Rezoning Transportation Analysis

Petition Number: 2022-119

Date	Description
12-29-22	First Review (TM)
02-23-22	Second Review (TM)
05-24-23	Third Review (TM)

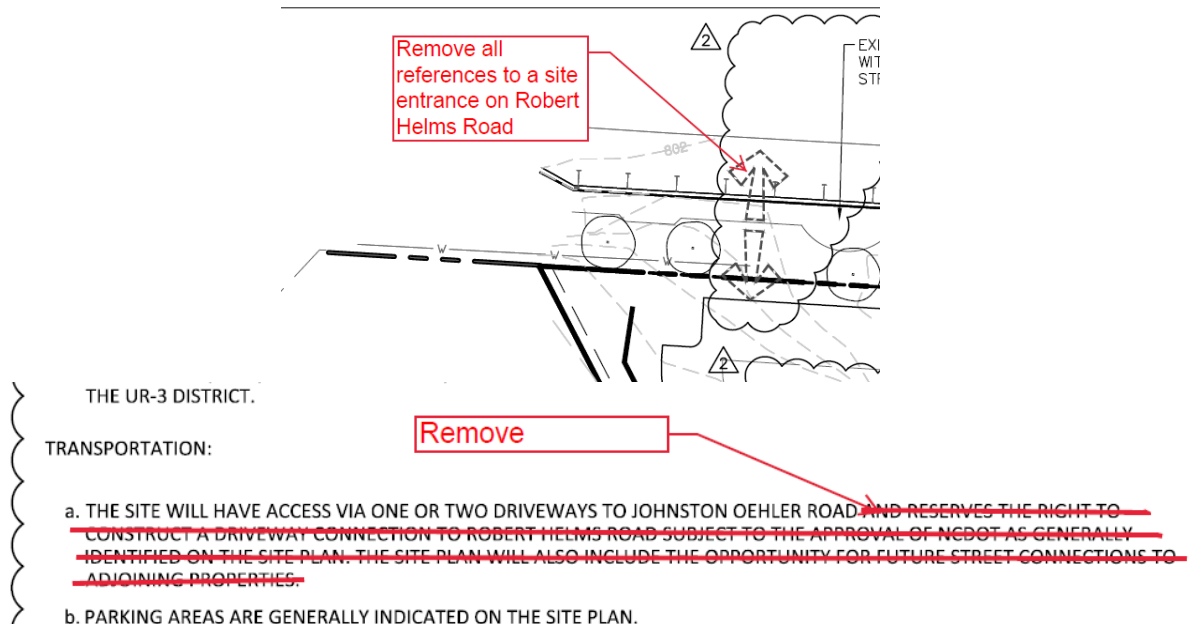
6. ~~The proposed dwelling units exceeds 12 per acre. Per Chapter 20 Subdivision ordinance, revise site plan and conditional note(s) to commit to construct an 8-foot planting strip, and 8-foot sidewalk along the public roadway extension. The wider sidewalk also meets the Charlotte WALKS Policy.~~

Reference (CLDSM standard detail U-03) for street typical.

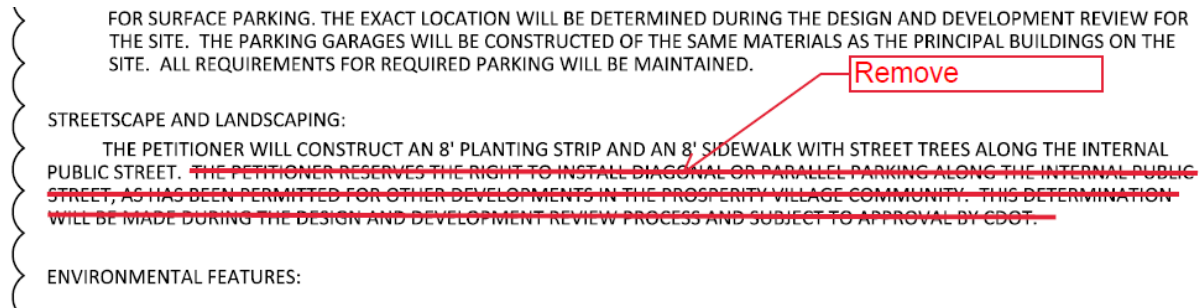
Clarifying Comment 02-22-23: Remove all mention of diagonal parking spaces
